April 23, 1997

RE: Addendum to the 30 Percent Remedial Design Technical Memorandum
Design Set 1B - Harbor Island S&GOU Superfund Site, Seattle, WA

Attachment A

Attachment C

ATTACHMENT B - REVISED FIGURE 3-1 DESIGN SET 1B SCHEDULE HARBOR ISLAND S&G OU

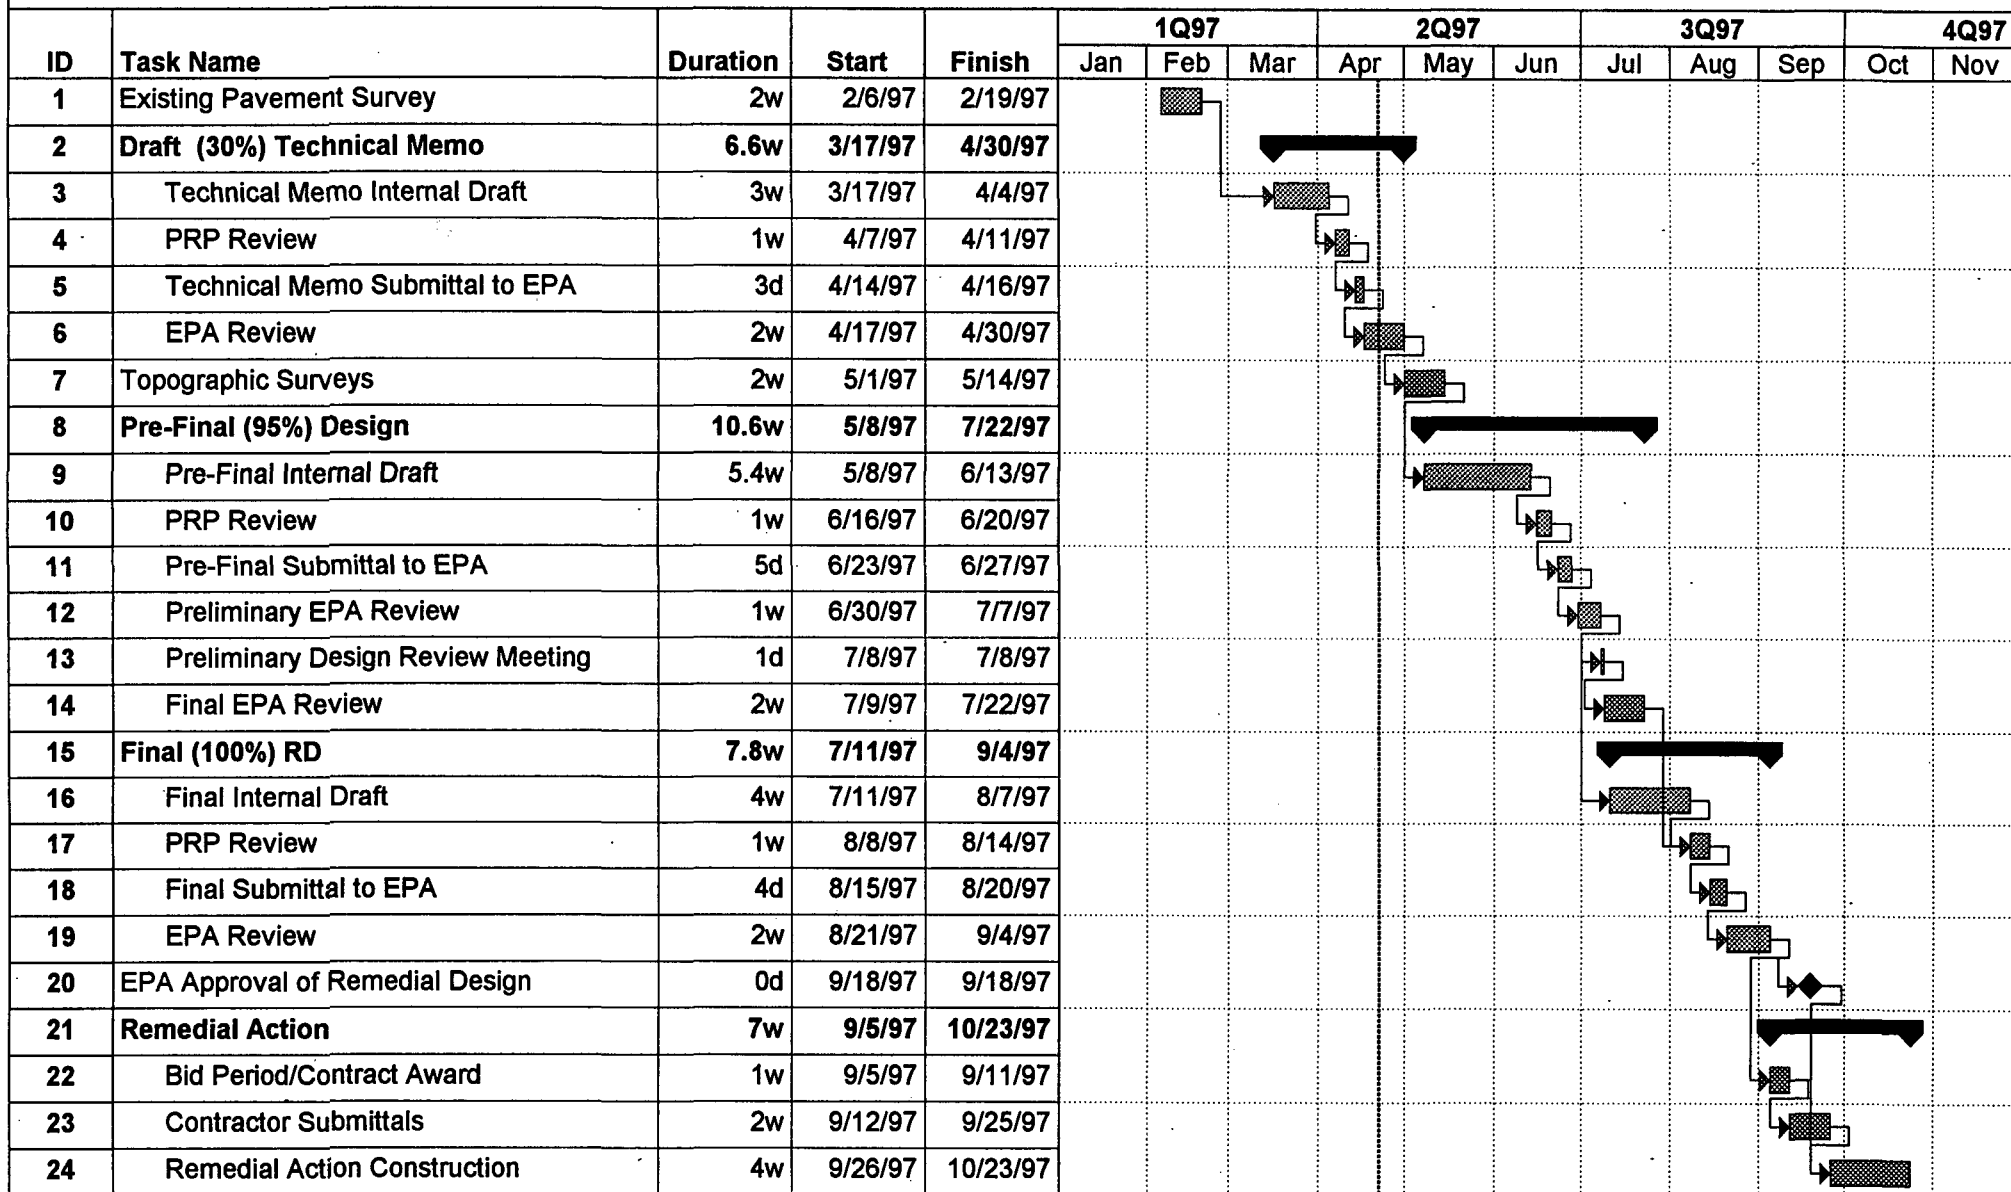
- 2) A revised design schedule (see Attachment B) that includes a two week EPA review period for both the 30 percent and 100 percent design submittals. We have also added a preliminary design review meeting for RETEC and EPA to occur during EPA's review of the 95 percent design submittal, and have also changed the start of the remedial action bid period to coincide with the completion of EPA review of the final design. Actual remedial activities would not start though until the design is approved by EPA. All of these schedule adjustments are intended to further expedite remedial activities.

PROPOSED NEW SAMPLING LOCATIONS
FORMER LONE STAR NORTHWEST

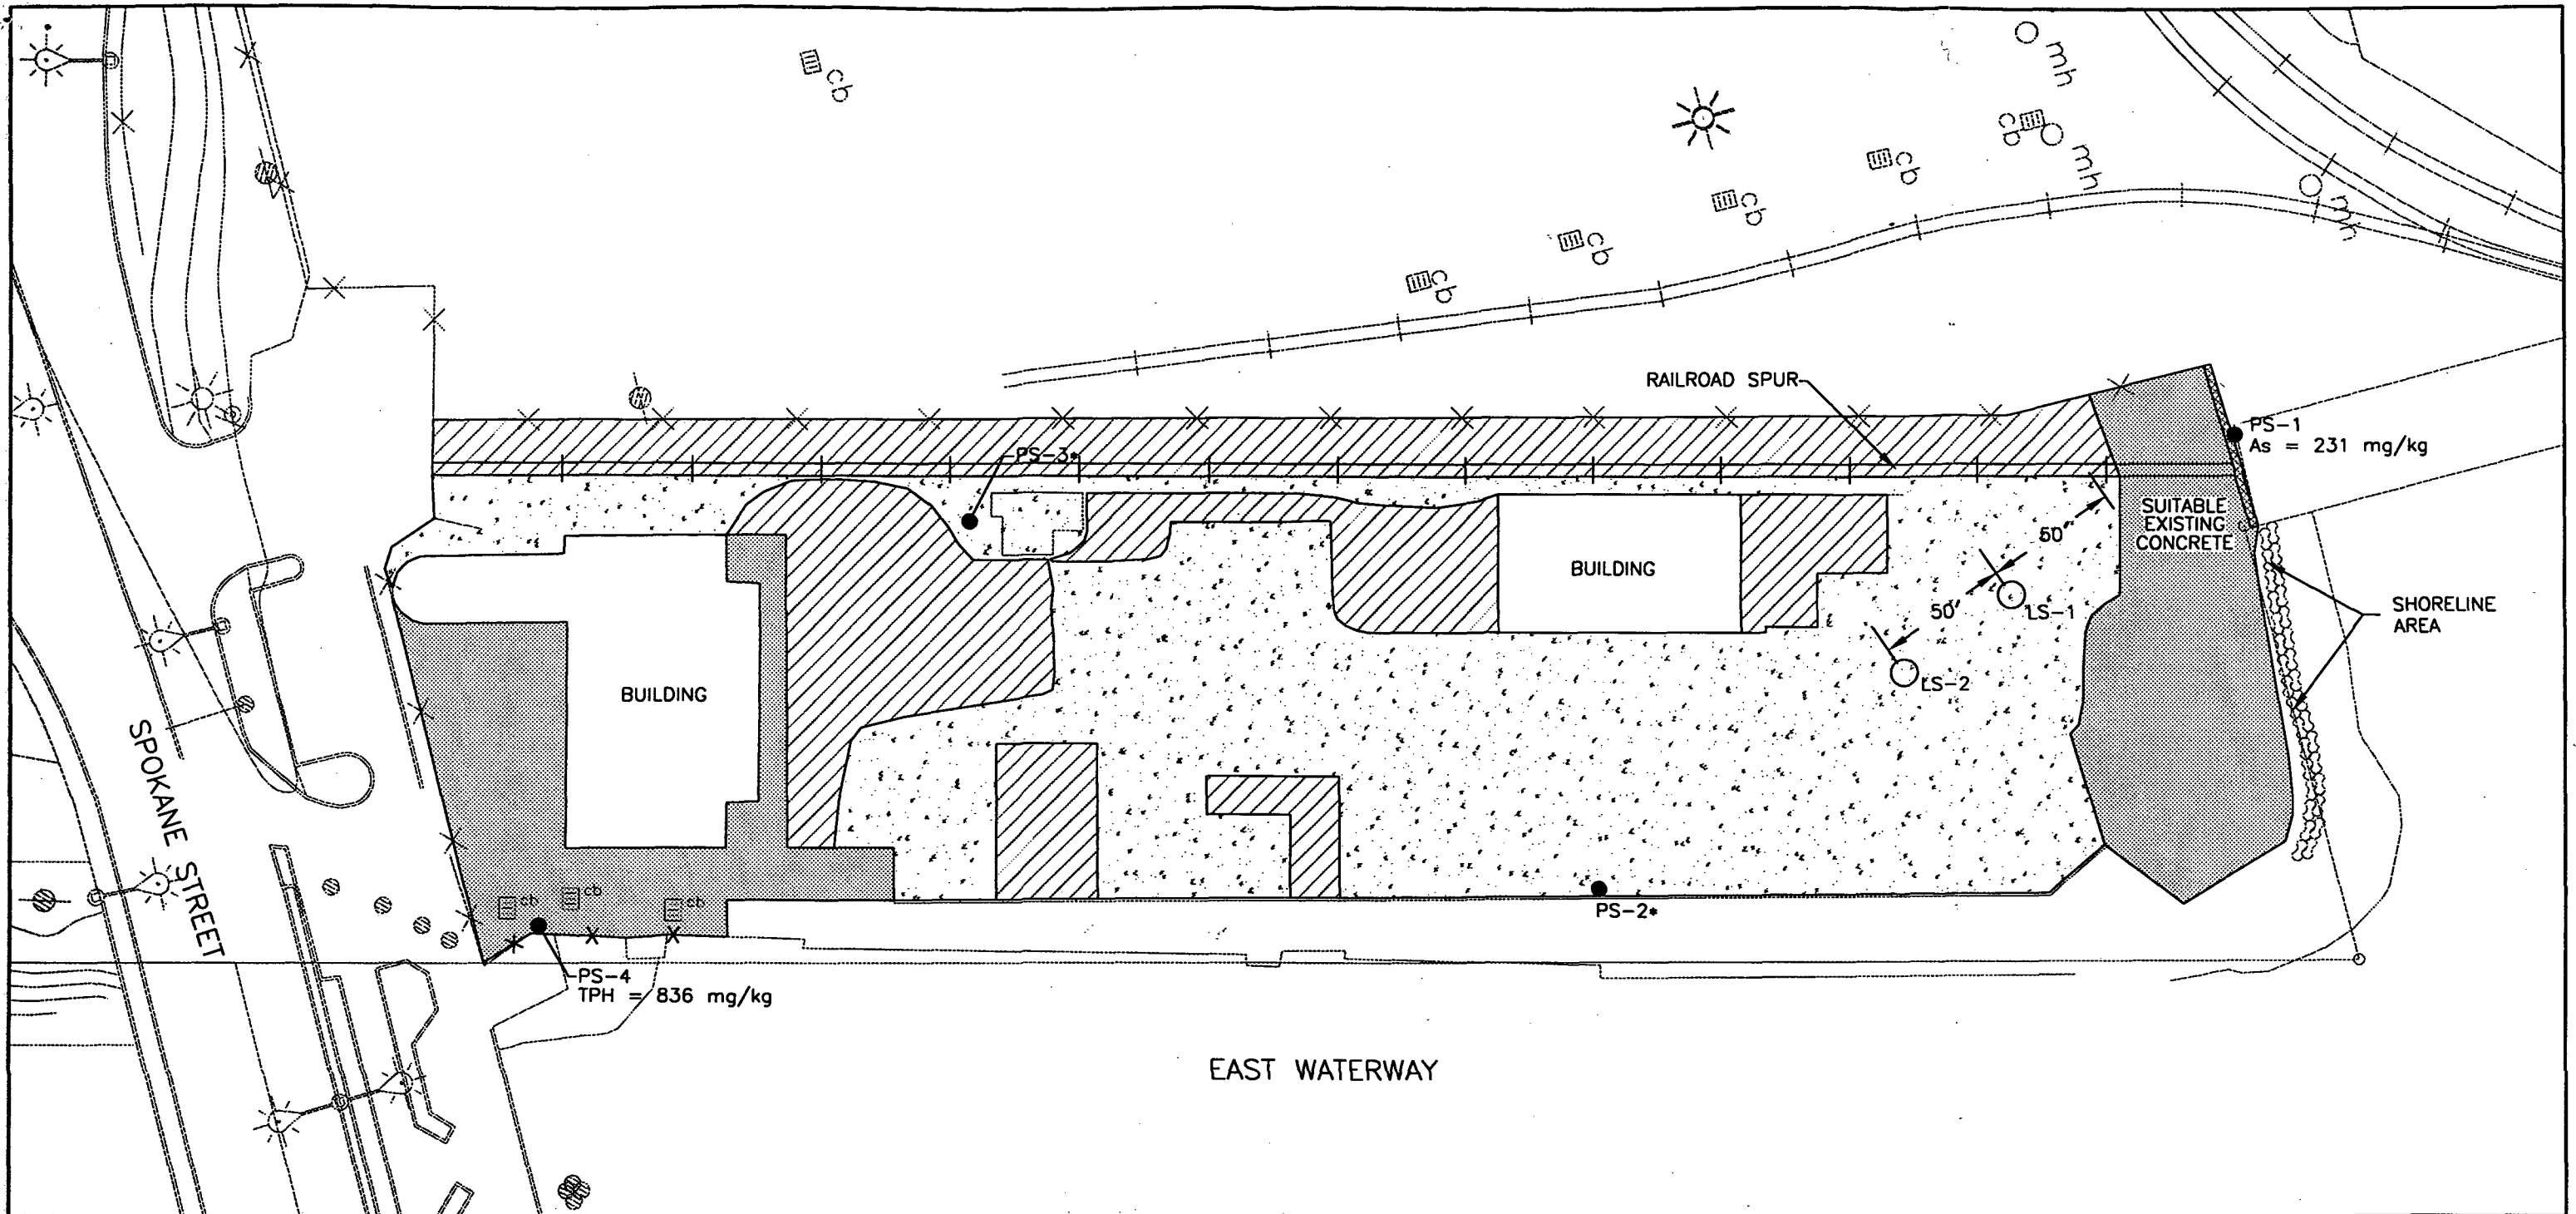
- 3) Additional surficial soil sampling procedures to further define the extent of asphalt capping required over predefined areas of arsenic-impacted soil at the for the former Lone Star Northwest property. Attachment C contains a brief description of the work to be performed, with references to portions of the *Harbor Island Sampling and Analysis Quality Assurance Project Plan, February 1991*, prepared by Roy F. Weston. The procedures defined in the Weston QAPP relevant to sample collection, handling and testing will be followed.

Additional surfacial soil (upper 6-inches) characterization will be completed at the former Lone Star Northwest property to further bracket the extent of documented arsenic impacts located along the northern property boundary. Figure 2 is a site map which includes previously collected sample locations from the RI along with two additional proposed sample locations.

Proposed sample locations (LS-1 and LS-2) are directly between PS-1 and PS-2. Sample LS-1 is approximately 50 feet southeast and sample LS-2 is approximately 100 feet southeast of the suitable existing concrete surrounding PS-1 (Figure 2).

Sample LS-1 will be analyzed, with a rush turnaround, for arsenic by EPA-CLP (Method 6010) as described in Section 9 of the Weston QAPP. If analytical results for this sample indicate arsenic concentrations exceed 188 mg/kg, sample LS-2 will also be analyzed for the presence of arsenic.
